**ATTACHMENT 1**

**Response to Request for Additional Information**

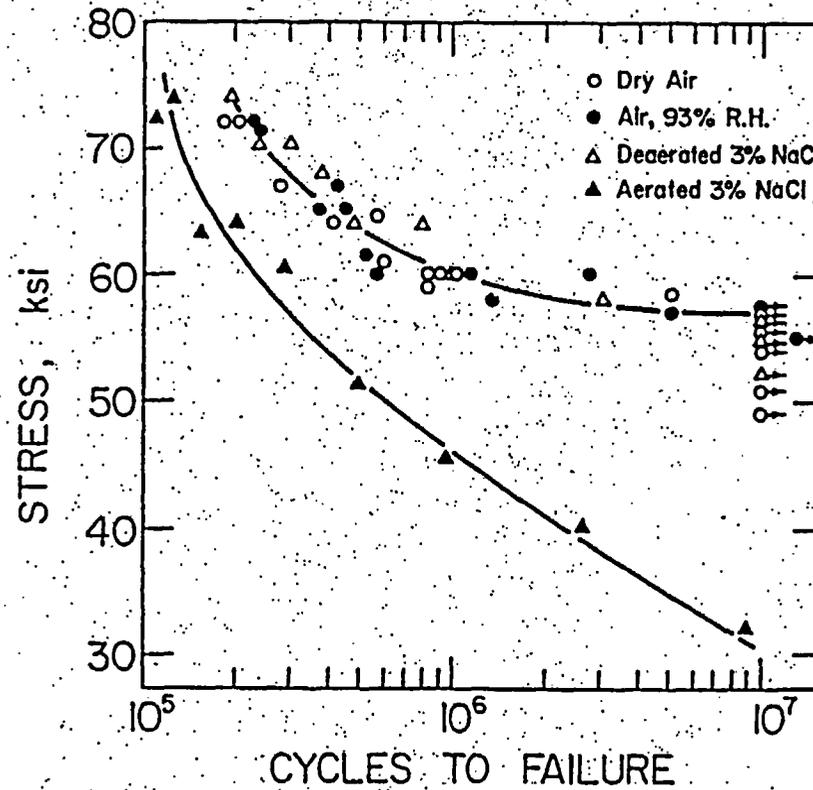
1. Provide the critical crack size that the master connecting rod will fail due to high cycle fatigue. Give length & depth or aspect ratio.

As shown in the attached photograph of the fracture surface, the critical crack size is about 7 inches in length by about 1 inch in depth (the thickness of the ligament). This determination is based on empirical data obtained from examination of the fracture face.

There is confirmation of the identification of the sub-critical fatigue crack from the final critical fast fracture in the well-preserved fracture surface. The attached photographs show the excellent beach marks that identify the fatigue crack covering the majority of the fracture surface.

Crack Initiation and Growth Timeline  
Plotted Along Engine Operating  
Hours

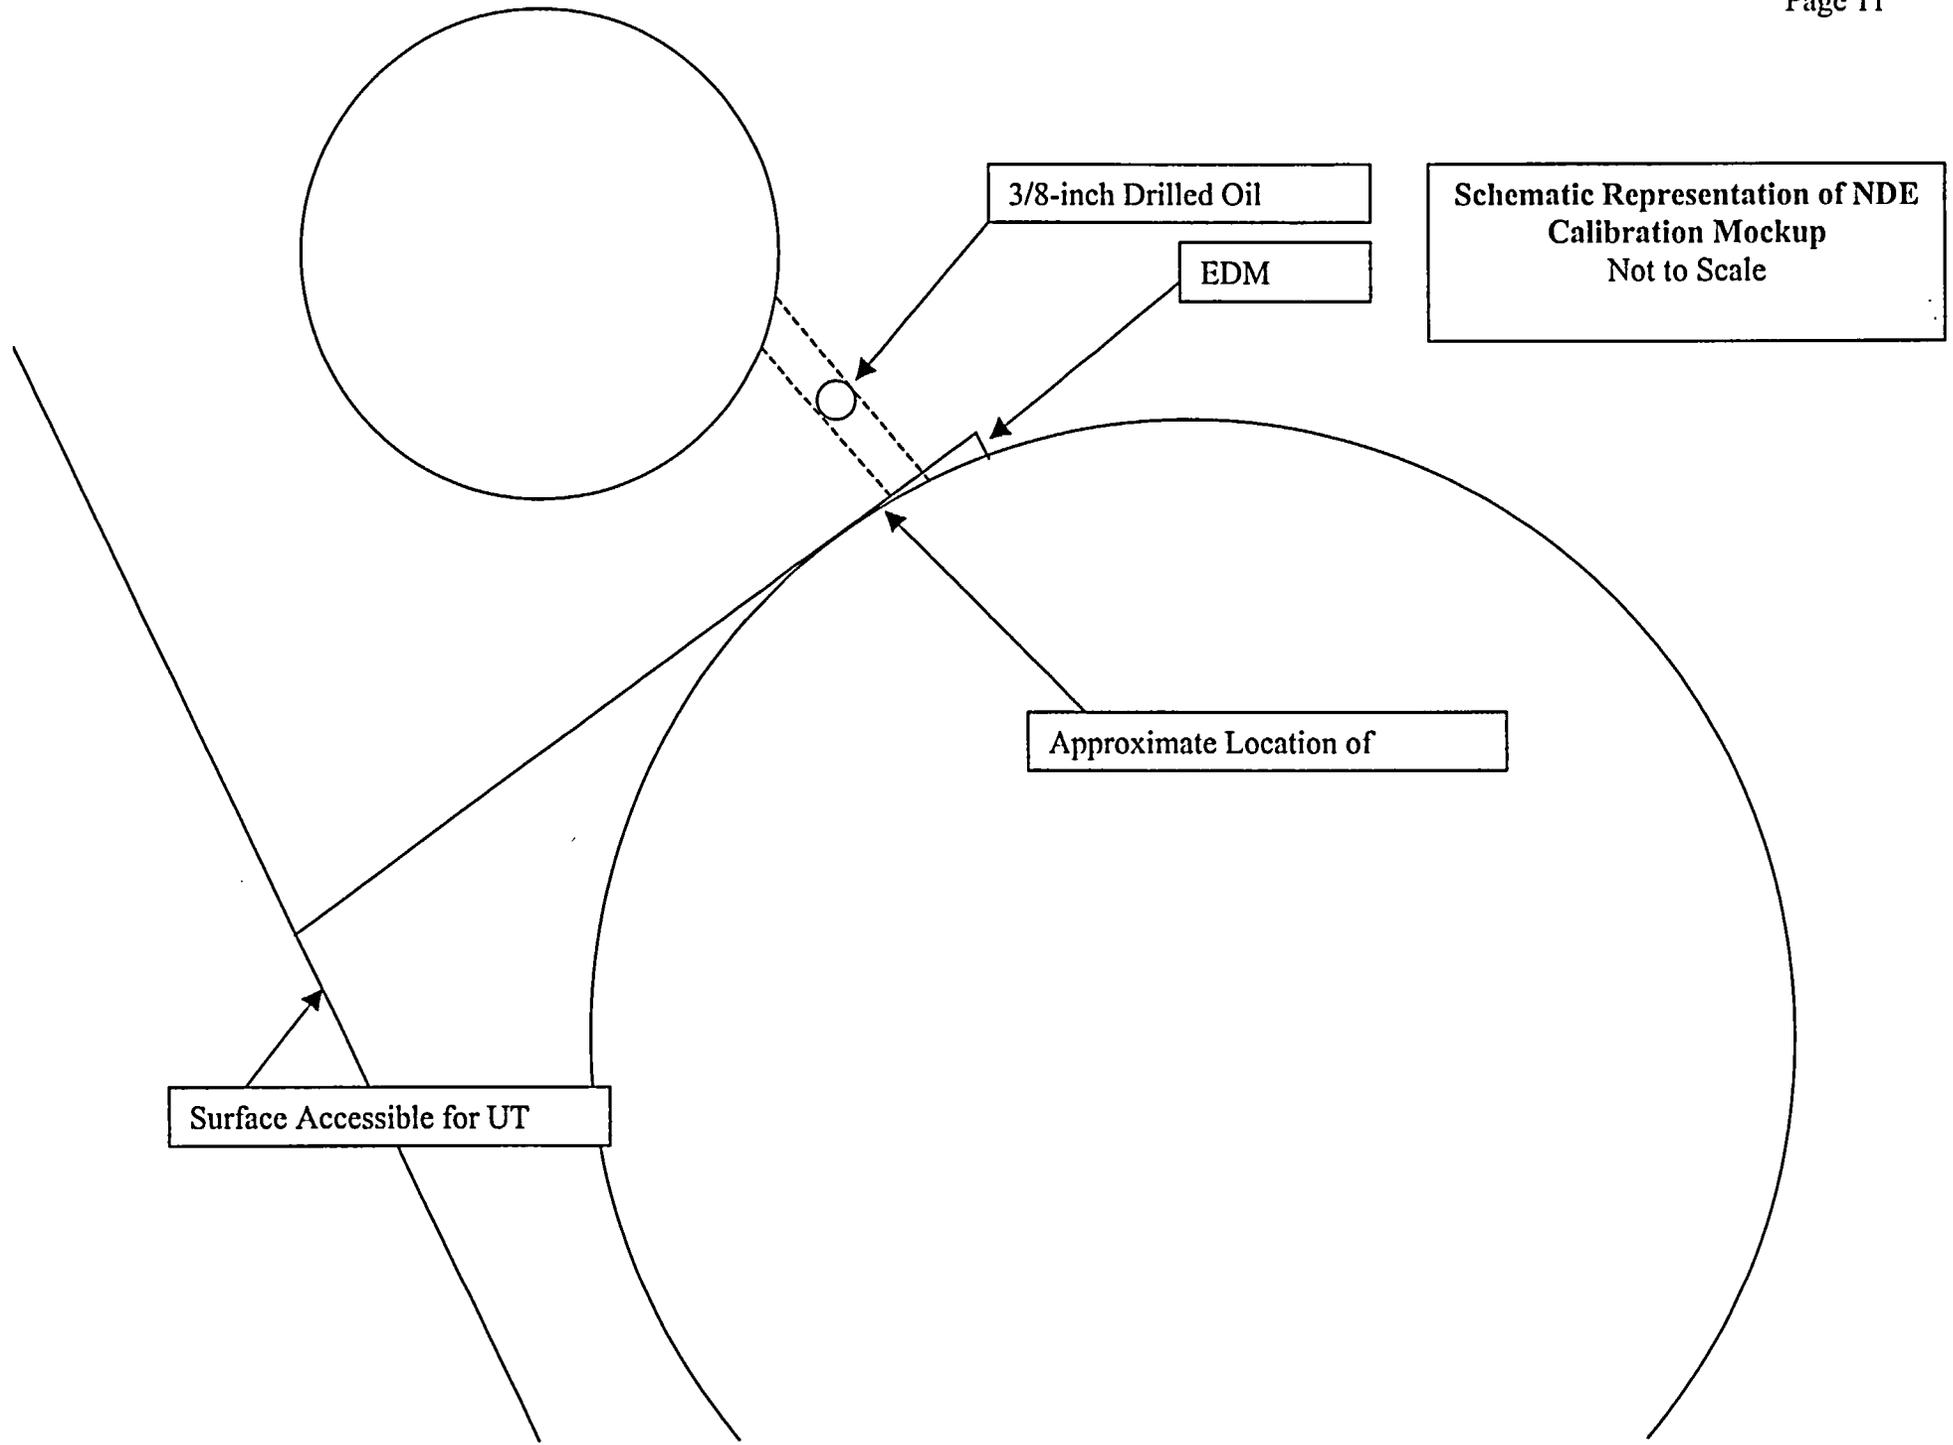
2. Provide a calculation that demonstrates that the minimal detectable crack size will not grow to the critical crack size and fail due to high cycle fatigue during the proposed interval between NDE inspections. The calculation needs to account for the possibility that an accident can occur prior to the end of the inspection interval and that the diesel will perform its mission without failure. The calculation should describe the results, the assumptions and inputs and method used so that an independent reviewer can verify the conclusions.

Therefore, in order to address the issue of establishing an inspection periodicity which precludes a similar failure on the rebuilt SDG22, the time for an assumed crack to grow to critical size is determined from the empirical data. The failure occurred following more than 2100 hours of accumulated engine operation. Subtracting the doubly conservative initiation time (1100 hours) and the time required to grow to detectable size (30 hours), the time for a crack to grow from just below the detectable size to critical size is 970 hours.

Since a detectable crack of a depth of 0.16 inches will take at least 970 hours to grow to critical size and cause connecting rod failure and in an emergency situation the diesel is required to provide 7 days (168 hrs) of continuous operation for plant safety, the indicated inspection interval would be calculated by subtracting 168 from 970 hours. This shows that if the connecting rods are inspected every  $(970 - 168 = 802)$  hours, they will maintain at least 168 hours of run time available, even if called on just before the next scheduled inspection. Therefore, an inspection interval of about 800 hours is considered acceptable (Ref. 7, 8, & 9). Per reference 11, inspections will be performed every 500 hours.
